1305 STEWART

PROJECT NUMBER
3034882-EG

PROJECT ADDRESS
1305 Stewart Street
Seattle, WA 98109

EDG 3 GUIDANCE

SITE PLAN UPDATES

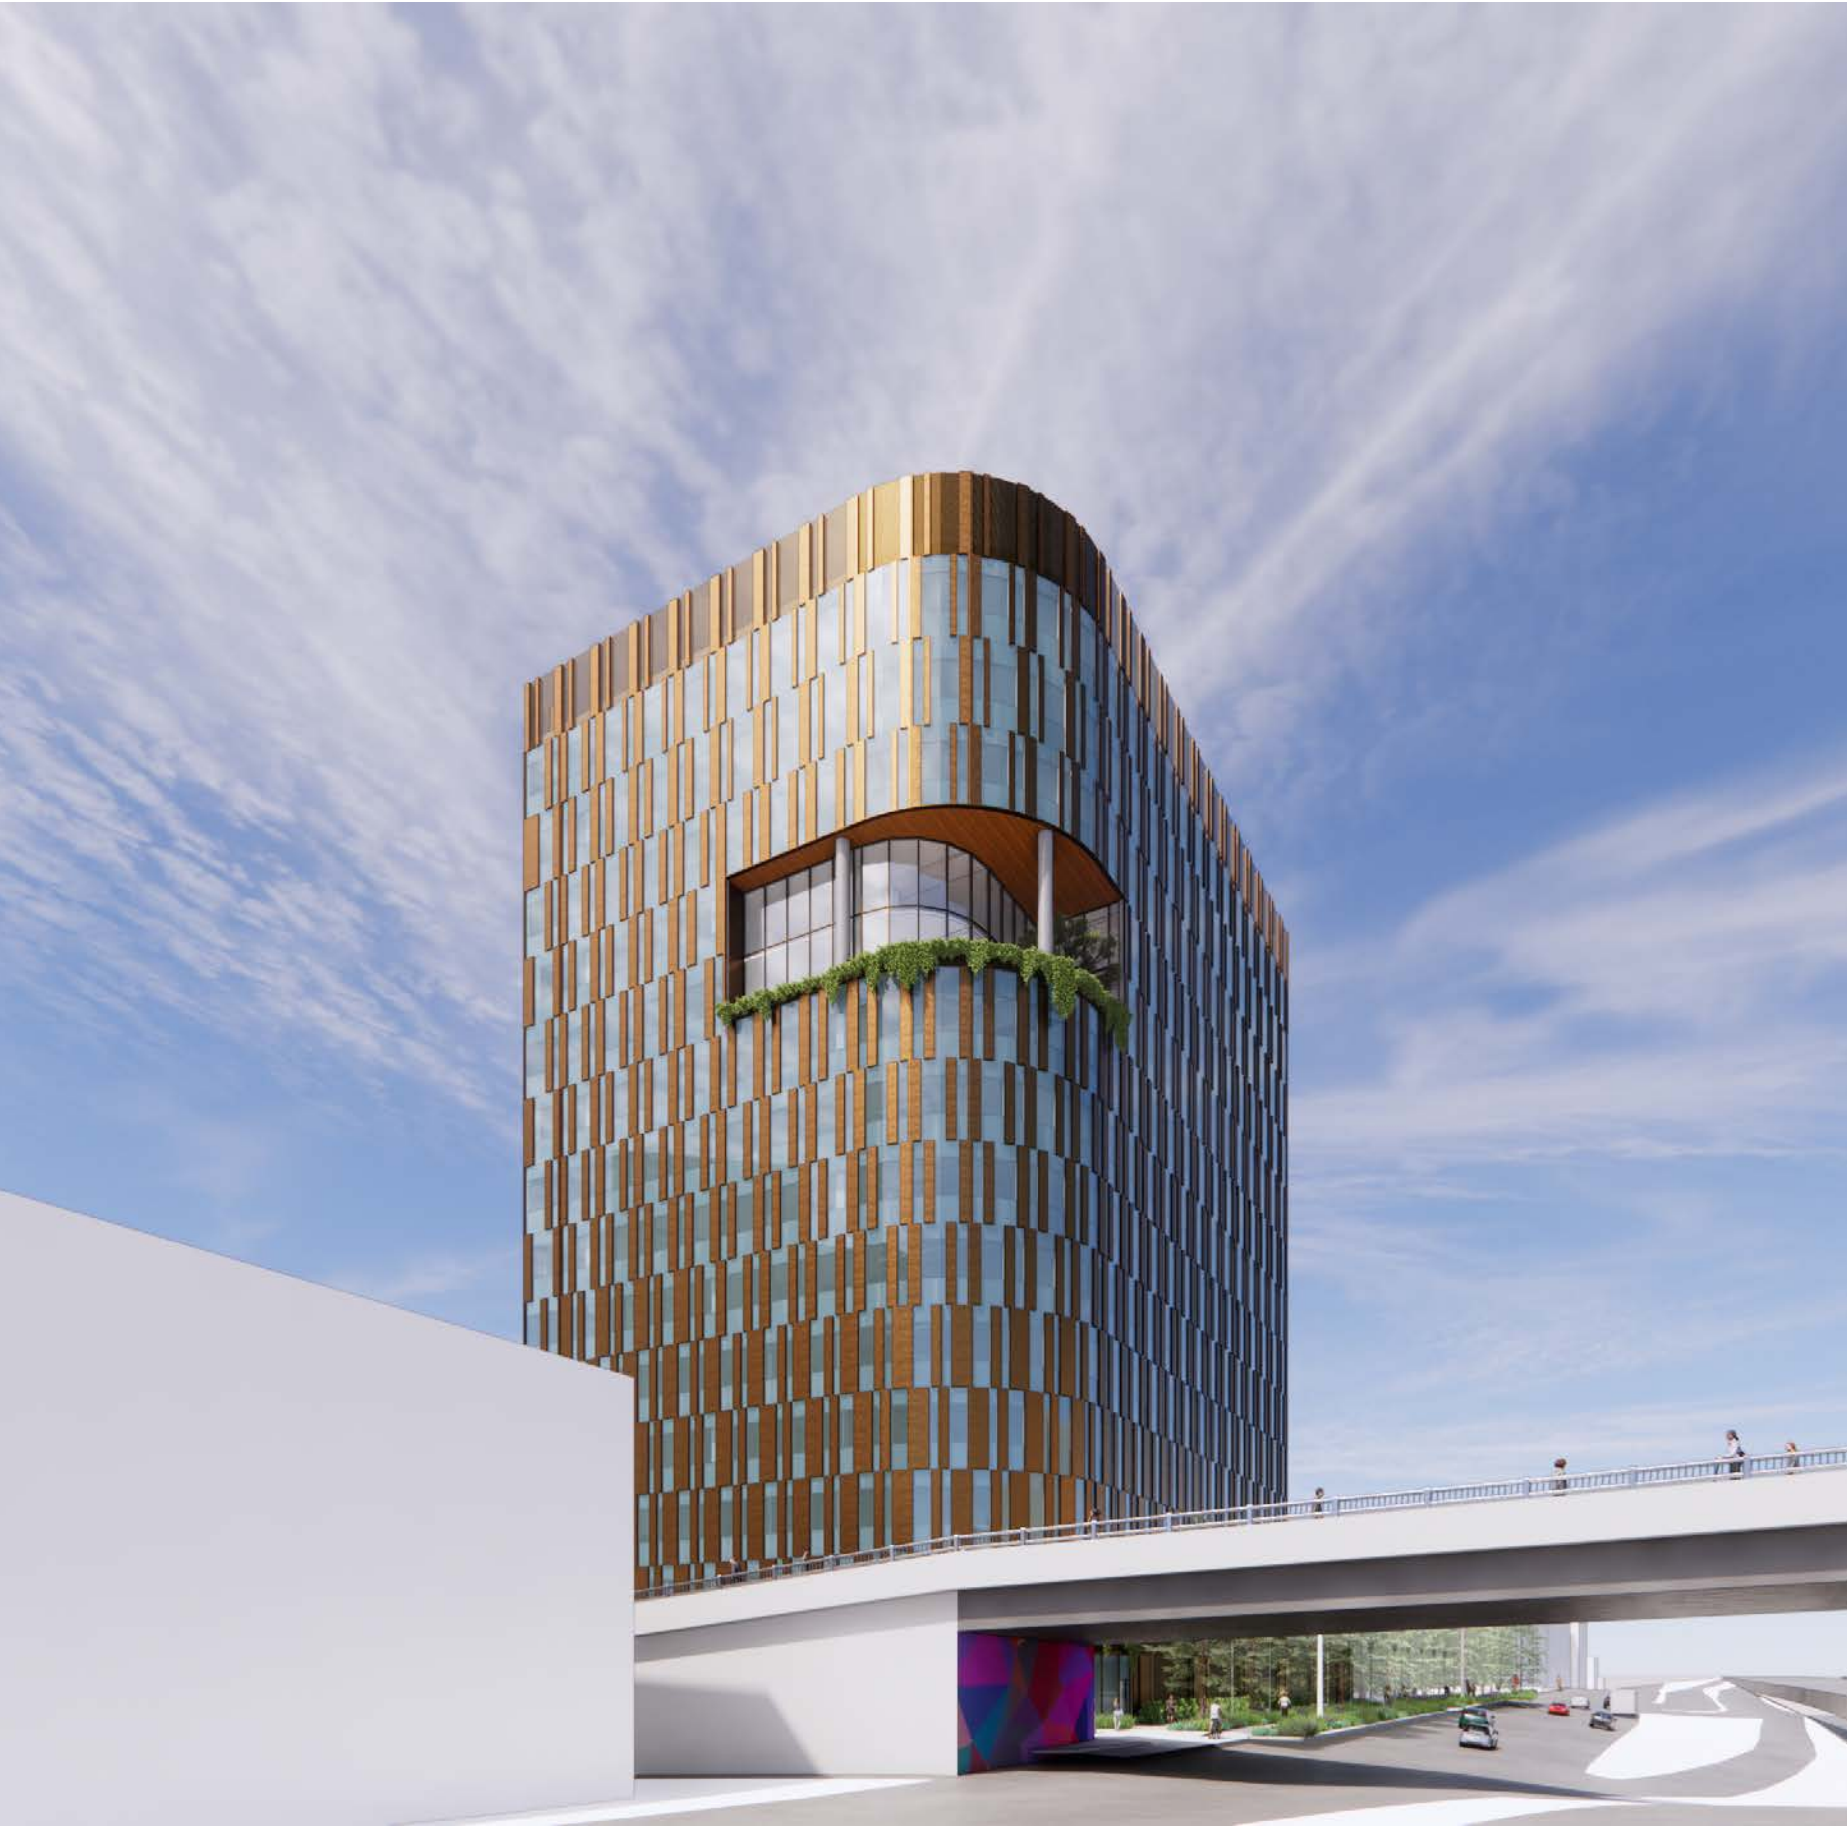
EDG3 Priorities & Board Recommendations /
2. Site Planning

a. The Board unanimously supported the inclusion of a large open space at the corner of Stewart Street and Denny Avenue and requested complete details for this area be provided at the Recommendation phase, including landscape, hardscape, site furnishings, aradina. retainina walls and structured planters. (PL1. PL1-1. DC3)

a. Complete details for the open space at the corner of Stewart Street and Denny Avenue are provided in this Recommendation submittal, including landscape, hardscape, site furnishings, grading, retaining walls and structured planters.

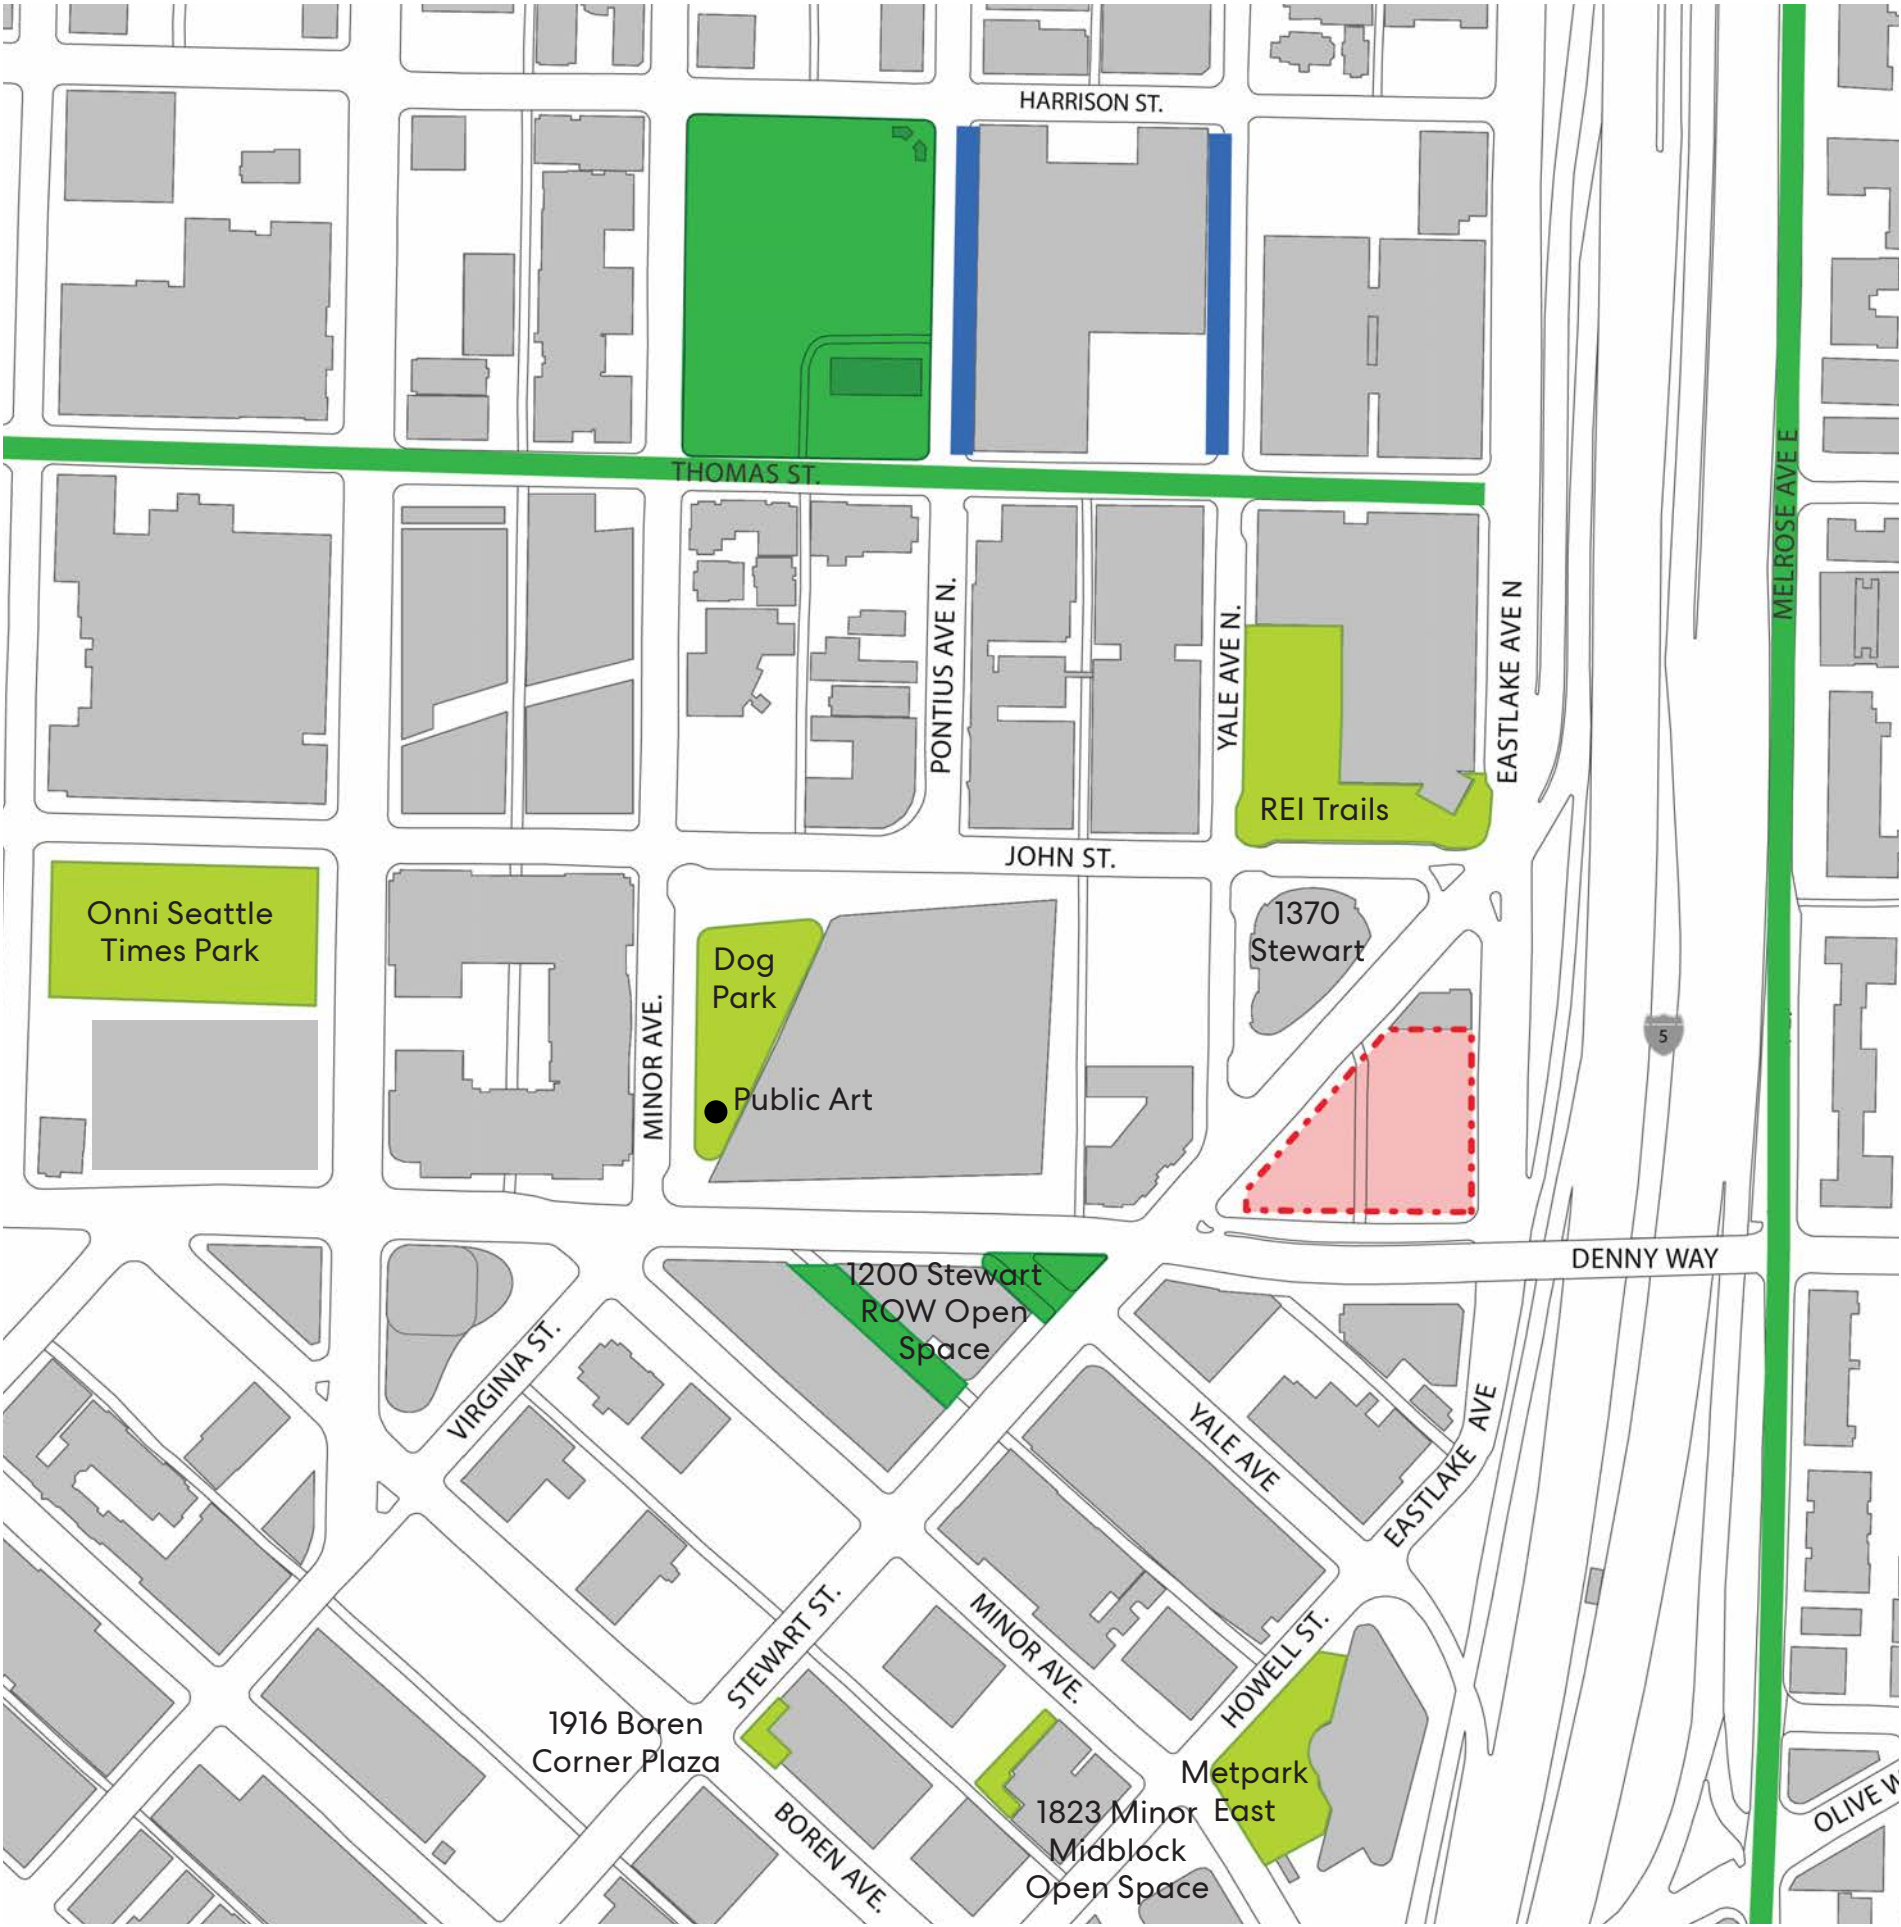
EDG3 Priorities & Board Recommendations /
2. Site Planning

b. The Board encouraged the applicant to see this site and landscape design as an element within the existing and emerging neighborhood context (per page 20 in the EDG packet) and supported the intent to coordinate and connect this new landscape design with those of Yale Avenue, the planned project to the north and the existing REI landscape. (PL1-A, PL1-I, PL1-B, PL1-C, DC3-A, DC3-B, DC3-C)

b. The site and landscape design is understood as an element within the existing and emerging neighborhood context. The design connects with those of Yale Avenue, the planned project to the north, and the existing REI landscape.

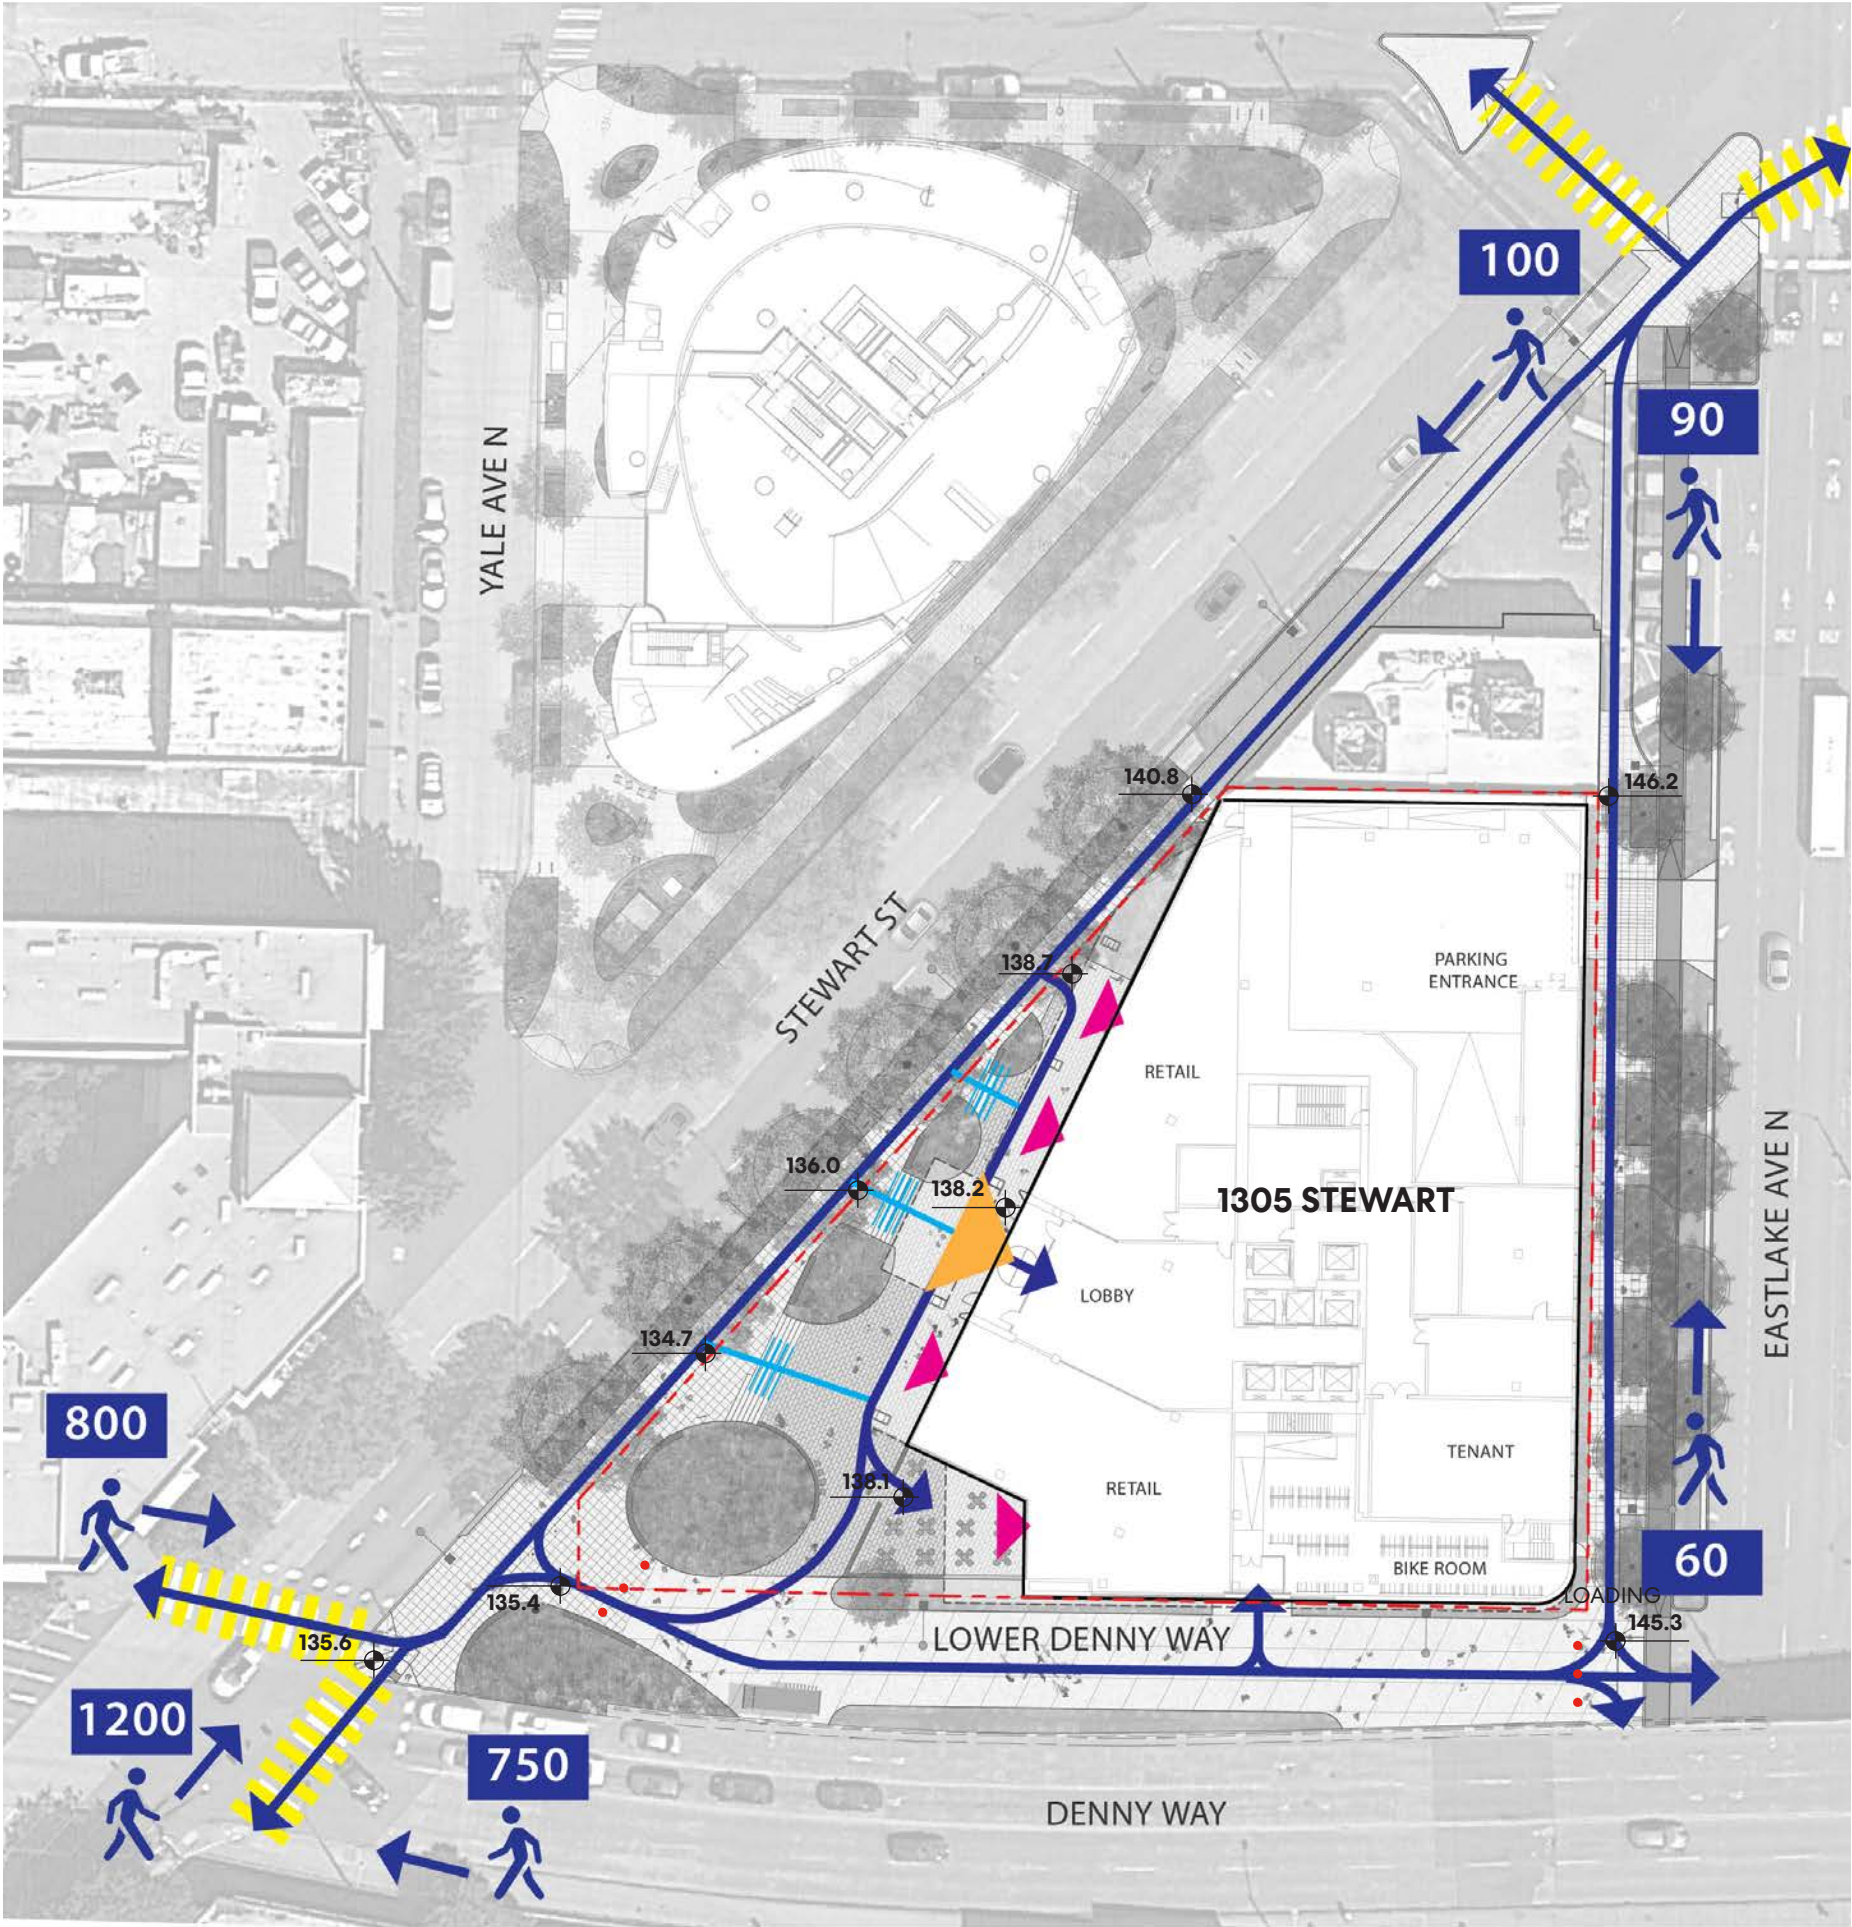
EDG3 Priorities & Board Recommendations /
2. Site Planning

c. The Board had questions about pedestrian use of open space and asked that the recommendation packet include clear identification of accessible routes of travel, as well as anticipated pedestrian patterns and public use of the open space. (PL4-A-1, PL2-A.1. PL1. DC3)

c. Clear identification of accessible routes of travel, as well as anticipated pedestrian patterns and public use of the open space, are diagrammed in the adjacent plan.
